DEPARTMENT OF TRANSPORTATION  
NATIONAL HIGHWAY TRAFFIC SAFETY ADMINISTRATION  
[49 CFR Part 571]

DOCKET NO. 2-6; NOTICE 4  
PROPOSED MOTOR VEHICLE SAFETY STANDARD

ROOF INTRUSION PROTECTION FOR PASSENGER CARS

Automobile Manufacturers Association, Inc.

LOAD DEVICE DISPLACEMENT AND ANGLE TO ENSURE ROOF STRUCTURE SYST

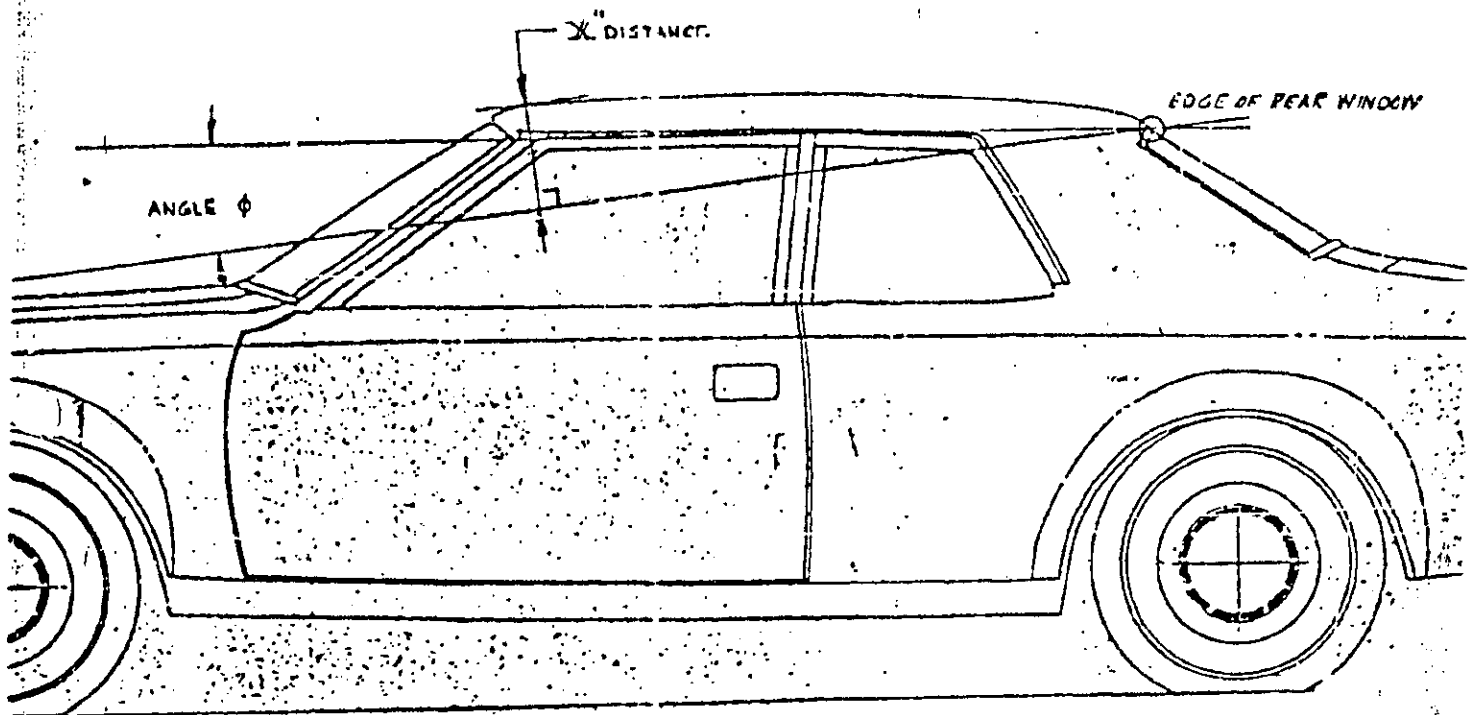
COMMENT: The 5-inch limit and the 12 by 12-inch test device in the test procedure overemphasize the performance of the windshield pillar and do not allow an adequate evaluation of the top structure performing as a system. Participation of center and rear roof pillars which can contribute to roof stability during rollover would not be evaluated with this limited deformation.

Attachment B indicates a geometric relationship which defines front body pillar displacements for typical passenger cars which will permit a total roof system strength evaluation. This information suggests the "A" pillar deformation dimensions at which rear roof pillar and front end sheet metal contribution to total roof strength can be evaluated for the size classes of vehicles listed in the chart.

Figure 1

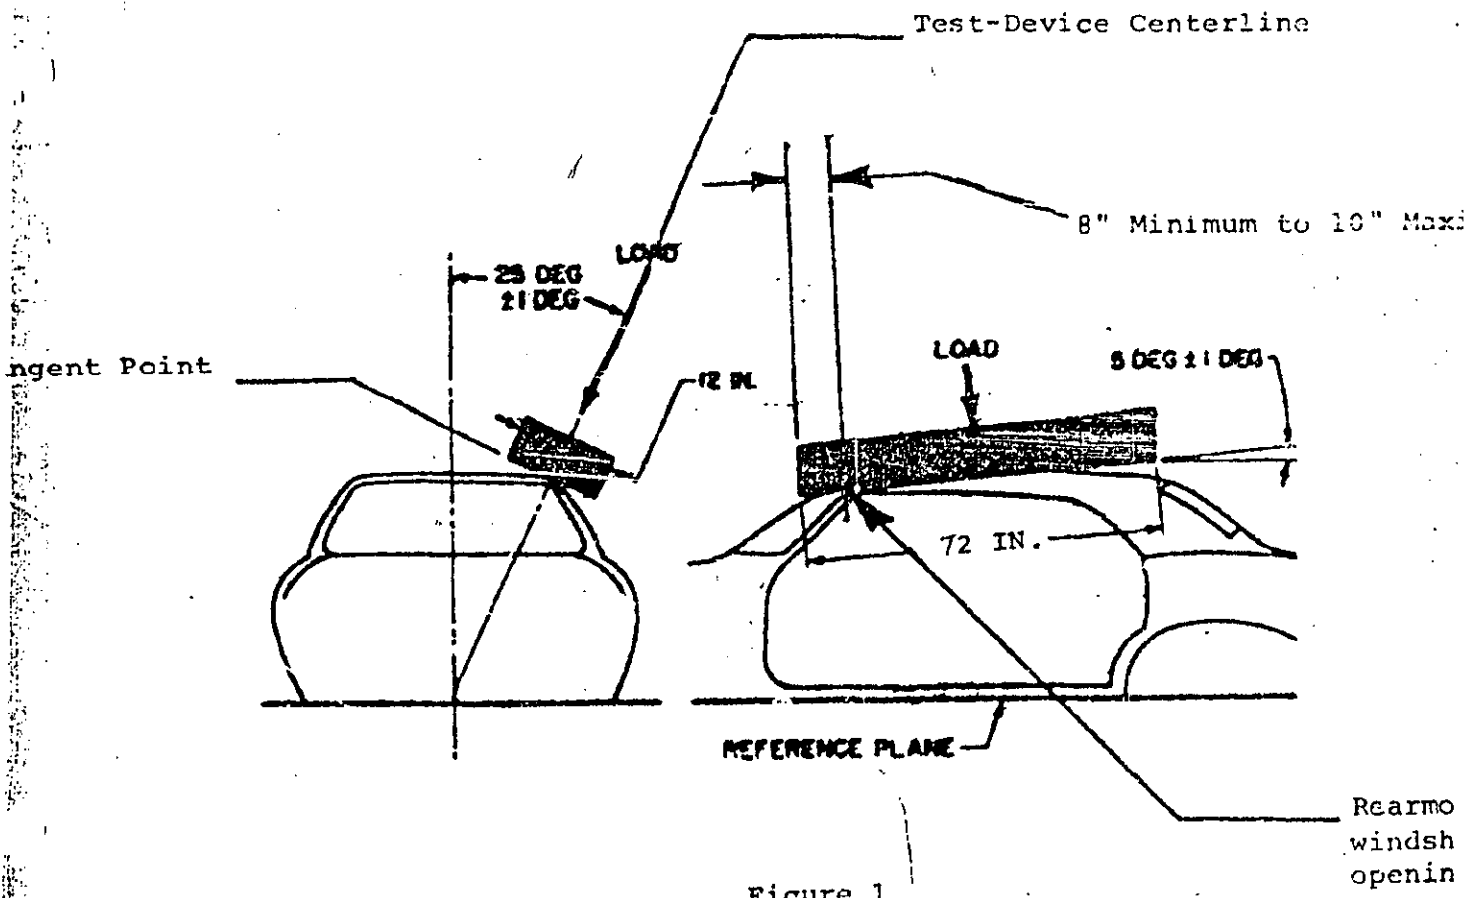
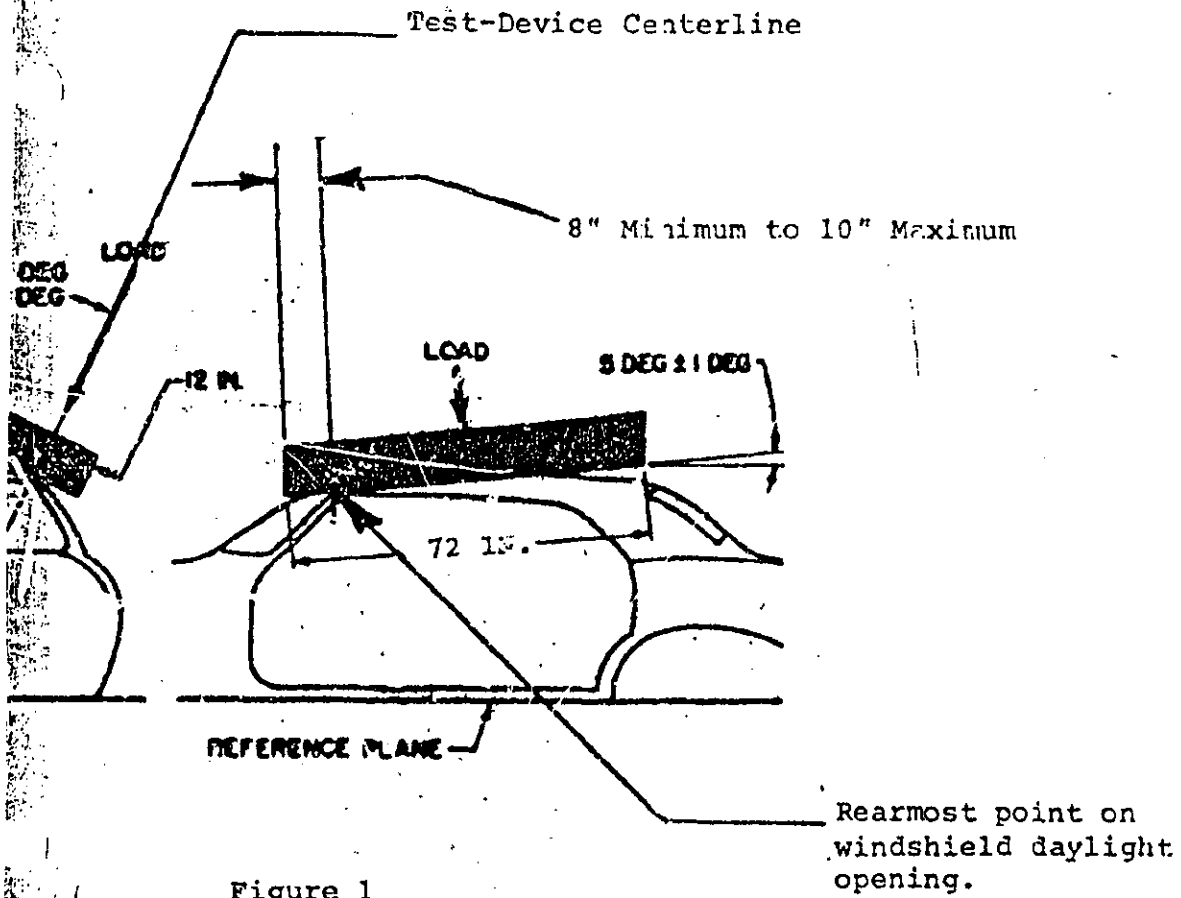
COMMENT: As noted in the comments to section S5 (S4 of AMA's rewrite), AMA requests that the Administration adopt the 12-inch by 72-inch load device defined in SAE Recommended Practice J374. Over two years of test experience with this device could be retained as useful information if the change mentioned above was adopted.

Comments on S4 (S3 of AMA's rewrite), Requirements, suggest establishing a roof system structural evaluation. This intent supports using 5° for the side view platen angle consistent with Recommended Practice SAE J374. Using the 12-inch by 72-inch load device, the provisions of S5.2(d) are then modified to assure adequate overlap of the load device with the roof structure. Consistent with these changes, Figure 1 is modified as shown in Attachment C.

Figure 1 would be changed as shown in Attachment C.

S~~6~~5.2 Orient the test device as shown in Figure 1, so that its lower surface--

- (a) Is at a forward (side view) angle of ~~XXX~~  $5^{\circ} \pm 1^{\circ}$  below the horizontal;
- (b) Is at a lateral (front view) outboard angle of  $25^{\circ} \pm 1^{\circ}$  below the horizontal;

(c) Has two edges parallel to the vertical plane through the vehicle's longitudinal centerline; and

(d) ~~At its center, it extends to the surface of the vehicle.~~ Extends not less than 8 nor more than 10 inches forward of the rearmost point on the windshield daylight opening. The point of tangency between the test device and the roof must be positioned to coincide with the longitudinal centerline of the test device lower surface.
